Item Name: Jack Saddle

DART AEROSPACE LTD		Work Order: 146777
Description: Jack Saddle		Part Number: D2281
Inspection Dwg: D2281 Rev: G		Page 1 of 1

DESIGN BW	DRAWN BY <i>[Signature]</i>	DART AEROSPACE LTD HAWKESBURY, ONTARIO, CANADA	
CHECKED <i>[Signature]</i>	APPROVED <i>[Signature]</i>	DRAWING NO. D2281	REV. G SHEET 1 OF 1
DATE 05.06.07		TITLE JACK SADDLE	SCALE 1:2
A	94.10.14	NEW ISSUE	
B	94.10.18	DIMENSION WAS 2.878	
C	94.11.04	ADD TOOLING NOTCH	
D	98.03.27	R0.350 WAS R0.280	
E	04.11.18	REMOVE TOOLING NOTCHES	
F	05.03.16	REDESIGN FLAT PATTERN	
G	05.06.07	REDESIGN FLAT PATTERN

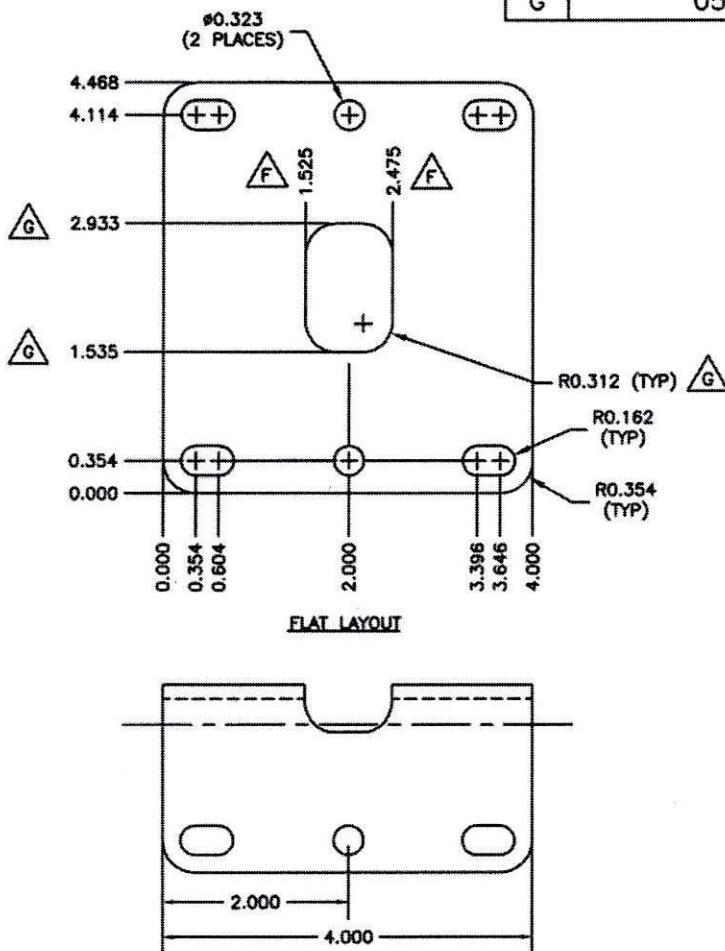
Drawing Dimension	Tolerance	Actual Dimension	Accept	Reject	Method of Inspection	Comments
4.468	+/-0.010	4.470	✓		PD-10	
4.114	+/-0.010	4.114	✓			
2.933	+/-0.010	2.932	✓			
1.535	+/-0.010	1.540	✓			
0.354	+/-0.010	.356	✓			
0.354	+/-0.010	.356	✓			
0.604	+/-0.010	.600	✓			
2.000	+/-0.010	2.010	✓			
3.396	+/-0.010	3.396	✓			
3.646	+/-0.010	3.646	✓			
4.000	+/-0.010	4.010	✓			
1.525	+/-0.010	1.535	✓			
2.475	+/-0.010	2.477	✓			
Ø0.323	+0.006/-0.001	.306	✓			.016 under tolerance
0.080	+/-0.010	.072	✓

customer po	part #	Qty	lot #	date done	cut by	quality spot check	Note
dart 32646	D-2281	30	see mill test	28/06/2016	GR	Jonathan Lessard Gabriel Rioux	.323 hole need to be drill due to tight tolerance and taper in thin material in @ .325 and out @ .312
dart 32646	D-2585	40	see mill test	28/06/2016	GR	Jonathan Lessard Gabriel Rioux	.191 hole need to be drill due to tight tolerance and taper in thin material in @ .191 and out @ .171
